Access Compliance Report

Public Rights-of-Way

Intersection ID: 9768	Main Street: EASTWAY_DR	Cross Street: THE_PLAZA	Location: NW
ADA ID: 401CD9FCB566	Ramp Type: PerpDiag	Initial Pass/Fail: Fail	Overall Compliance: No
		Severity Score: 22.5

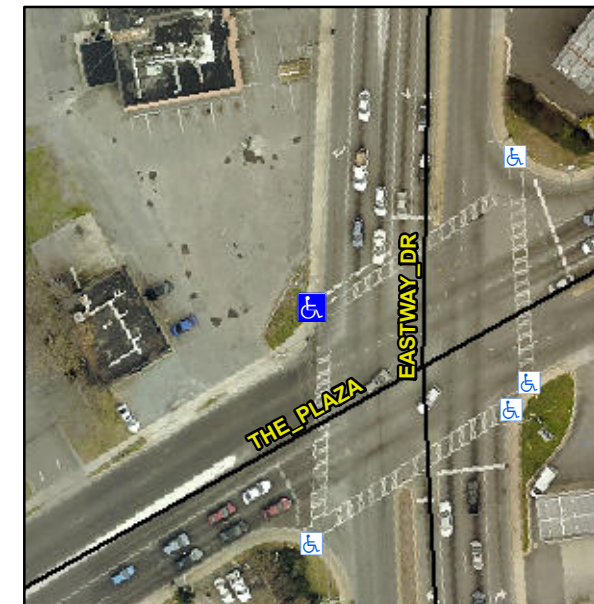
Not Found, R304.5.1, R304.2.2, R304.5.3

Compliance	Description	Data	Compliance	Description	Data
N/A	Ramp Length (in)	62.0	No	Ramp Slope (%)	10.0
No	Ramp Width (in)	43.0	No	Ramp XSlope (%)	3.0
N/A	Flare Type LT	N/A	N/A	Flare Type RT	N/A
N/A	Flare Slope LT (%)	N/A	N/A	Flare Slope RT (%)	N/A
N/A	Flare Traversable LT?	N/A	N/A	Flare Traversable RT?	N/A
N/A	Landing Length (in)	N/A	N/A	DWS Provided?	N/A
N/A	Landing Width (in)	N/A	N/A	DWS Contrast?	N/A
N/A	Landing Slope (%)	N/A	N/A	DWS Length (in)	N/A
N/A	Landing X Slope (%)	N/A	N/A	DWS Full Width?	N/A
N/A	Landing Curb? (Y/N)	N/A	N/A	DWS Offset (in)	N/A
N/A	Shared Landing?	N/A			
N/A	Gutter Ponding?	N/A	N/A	Gutter Slope (%)	N/A
N/A	Gutter Lip Ht (in)	N/A	N/A	Gutter X Slope (%)	N/A
N/A	Painted X Walk1?	Yes	N/A	Painted X Walk2?	Yes
	X Walk 1 Direction	To SW		X Walk 2 Direction	To NE
N/A	X Walk 1 Width (in)	73.0	N/A	X Walk 2 Width (in)	57.0
	X Walk 1 Slope (%)	0.6		X Walk 2 Slope (%)	0.9
	X Walk 1 X Slope (%)	1.4		X Walk 2 X Slope (%)	1.3

Remove & Replace Curb Ramp With Two New Directional Ramps or Equivalent.
